# UNITED STATES PATENT AND TRADEMARK OFFICE

<b>Advisory Action Before the Filing of an Appeal Brief</b>	<b>Application No.</b>	<b>Applicant(s)</b>
	10/605,598	HULTEN ET AL.
	<b>Examiner</b> Mariano Sy	<b>Art Unit</b> 3683

**FIG.3**

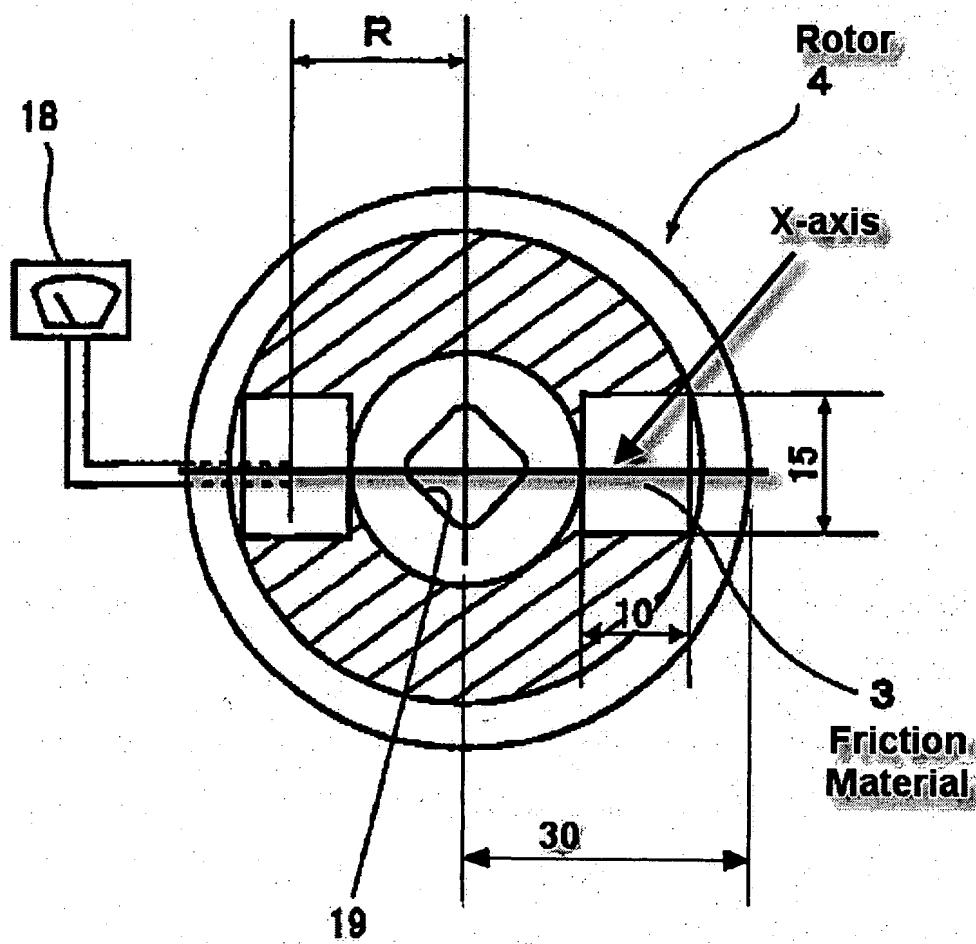
The sizes and dimensions of the rotor 4 and friction material 3 disclosed by Okayama et al. (US 6,620,860) are proportional for a typical disk brake used in a vehicle.

The claims are directed to a disk brake wherein the ratio B/R between the radial extent B of lining 32 and radius R of rotor 8 is less than 0.38.

Okayama et al. disclosed in fig. 3 and col. 6, lines 13-25 wherein the ratio is 0.30 (rotor diameter is 60 and width of brake lining is 10) which is less than 0.38, wherein the radial extent of the brake lining (read from the x-axis, horizontal) is 10 and the radius of the rotor is 30. The dimensions of the brake lining and the size of the rotor clearly show the relationship between the rotor and the brake lining, since the brake lining cannot be too small or too large with respect to the size of the rotor in order to provide effective braking, that is why Okayama et al. didn't picked or selected any sizes and dimensions for the rotor and the brake lining of the disclosure in fig. 3. As for the parameters such as braking torque and modulus of elasticity are based on the composition of the material being used.

This clearly reads on the claim language. See Fig. 3 of Okayama et al. as shown below.
